Access Compliance Report Public Rights-of-Way (Curb Ramps)

Main Street: HOLT_AVE		Cross Street: WARREN_AVE		Location:	SW
ADA ID: RPRK220121122751	Ramp Type: Type 4 - Parallel	Initial Pass/Fail: Fail	Overall Compliance: No	Severity Score:	15
Codes/Mitigation Info/Possible Solution			Field Measurements/Component Compliance

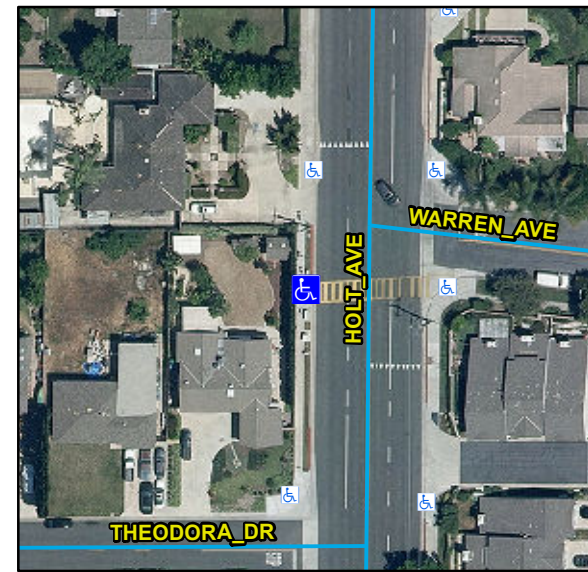
Compliance	Description	Data	Compliance	Description	Data
N/A	Ramp Length LT (in)	74	N/A	Ramp Length RT (in)	72
Yes	Ramp Width LT (in)	84	Yes	Ramp Width RT (in)	84
Yes	Ramp Run Slope LT (%)	3.8	Yes	Ramp Run Slope RT (%)	6.8
No	Ramp Cross Slope LT (%)	2.9	No	Ramp Cross Slope RT (%)	6
N/A	Landing Present	N/A	N/A	DWS Provided	N/A
N/A	Landing Length (in)	N/A	N/A	DWS Contrast	N/A
N/A	Landing Width (in)	N/A	N/A	DWS Length (in)	N/A
N/A	Landing Run Slope (%)	N/A	N/A	DWS Full Width	N/A
N/A	Landing Cross Slope (%)	N/A		DWS Offset Type	N/A
N/A	Landing Movement Obstructed?	N/A	N/A	DWS Offset Left (in)	N/A
	Landing Movement Type	N/A	N/A	DWS Offset Right (in)	N/A
N/A	Landing Shared	N/A			
N/A	Clear Space	N/A			
N/A	Clear Space To Crosswalk (in)	N/A			
N/A	Marked Crosswalk 1	Yes	N/A	Marked Crosswalk 2	N/A
	Crossing 1 Direction	E		Crossing 2 Direction	N/A
	Marked Crosswalk 1 Width (in)	144		Marked Crosswalk 2 Width (in)	N/A

Remove & Replace Entire Ramp.

R304.5.3, STD 1115
